**City of Urbandale
Supplemental Specifications
To Iowa Statewide Urban Design and Specifications
Standard Specifications for Public Improvements – 2020 Edition
May 2020**

FIGURE 7030.101 SHEET 1 OF 1

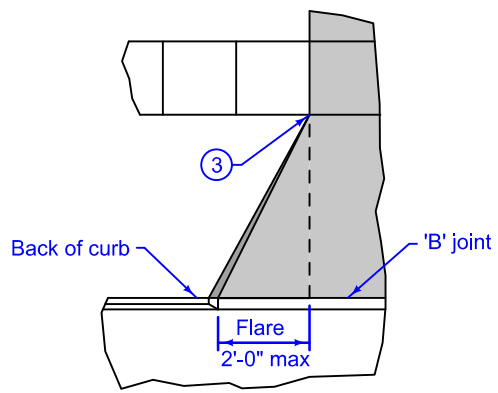
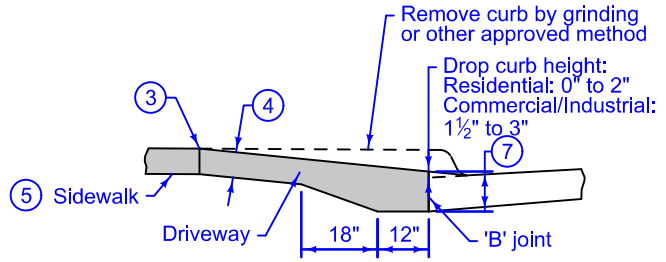
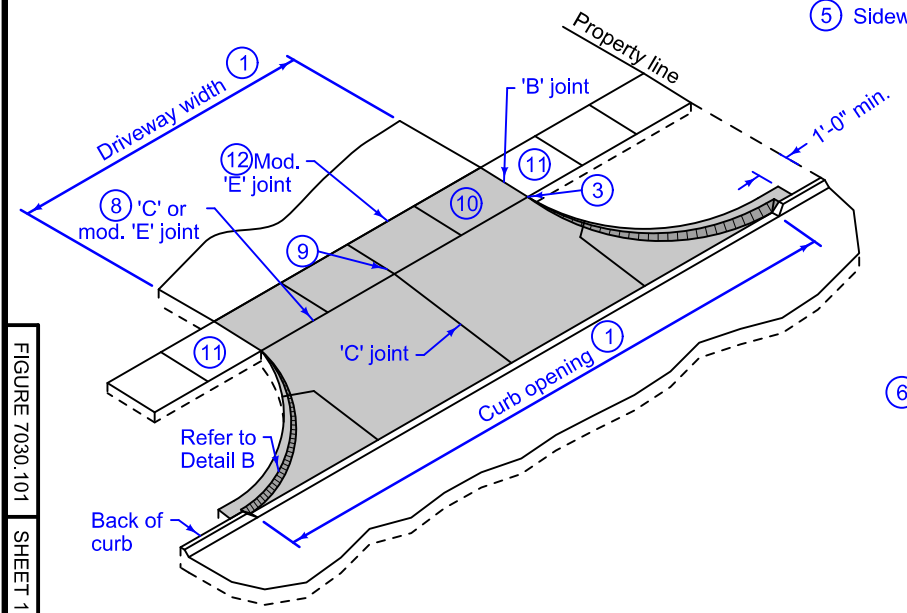
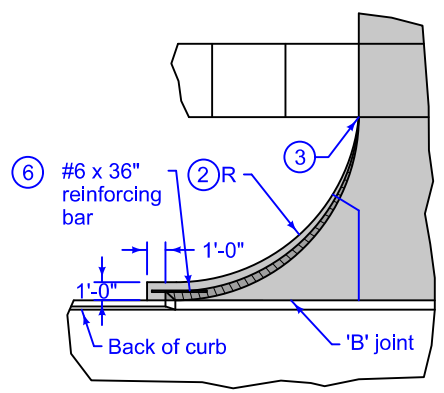
Division	Section	Page/ Figure	Description of Change
7	7030 3.04	9	3.04,D Replace with "Comply with Section 7010".
7	7030	7030.101	Replace with Urbandale Figure 7030.101
7	7030	7030.102	Replace with Urbandale Figure 7030.102
7	7030	7030.204	Replace with Urbandale Figure 7030.204
9	9070 1.03	1	1.03,D Insert "D. Submit a minimum of three color choices, not to include gray, from the Manufacturer's standard colors for approval."
9	9070 2.01	3	2.01,A,1 Insert "e. block weight to be minimum 100 pounds per block."
9	9071 2.01	1	1.03,F Insert "F. Submit a minimum of three color choices, not to include gray, from the Manufacturer's standard colors for approval."

- ① Driveway width (W).
Residential: 8 foot minimum, 24 foot maximum at sidewalk and at property line, 28 foot maximum at street.
Commercial and industrial: As specified in the contract documents.

- ② Driveway radius (R).
Residential: 10 foot minimum, 15 foot maximum.
Commercial and industrial: As specified in the contract documents.
- ③ Transition the curb height to 0 inches at end of taper/radius or at the front edge of sidewalk. Do not extend raised curb across sidewalk.

- ④ Pavement thickness.
Residential: 6 inches minimum.
Commercial and industrial: 7 inches minimum.
- ⑤ Sidewalk thickness through driveway to match thickness of driveway.

- ⑥ Center reinforcing bar vertically in the pavement.
- ⑦ Match thickness of adjacent roadway, 8 inches minimum.
- ⑧ Provide 'C' joint when sidewalk and drive approach are both being built.
Provide 1/2" 'E' joint when sidewalk is existing.

- ⑨ For alleys, invert the pavement crown 2% toward center of alley.
- ⑩ Target cross slope of 1.5% with a maximum cross slope of 2.0%. If specified in the contract documents, construct the sidewalk through the driveway 6 feet wide to serve as a passing space.

- ⑪ If cross slope of adjacent sidewalk panel exceeds 2.0%, remove and replace to transition from existing sidewalk to sidewalk through driveway. If elevation change requires a curb ramp, comply with SUDAS Figure 7030.206; verify need for detectable warning panel with Engineer.

- ⑫ Use 1/2" expansion joint material.
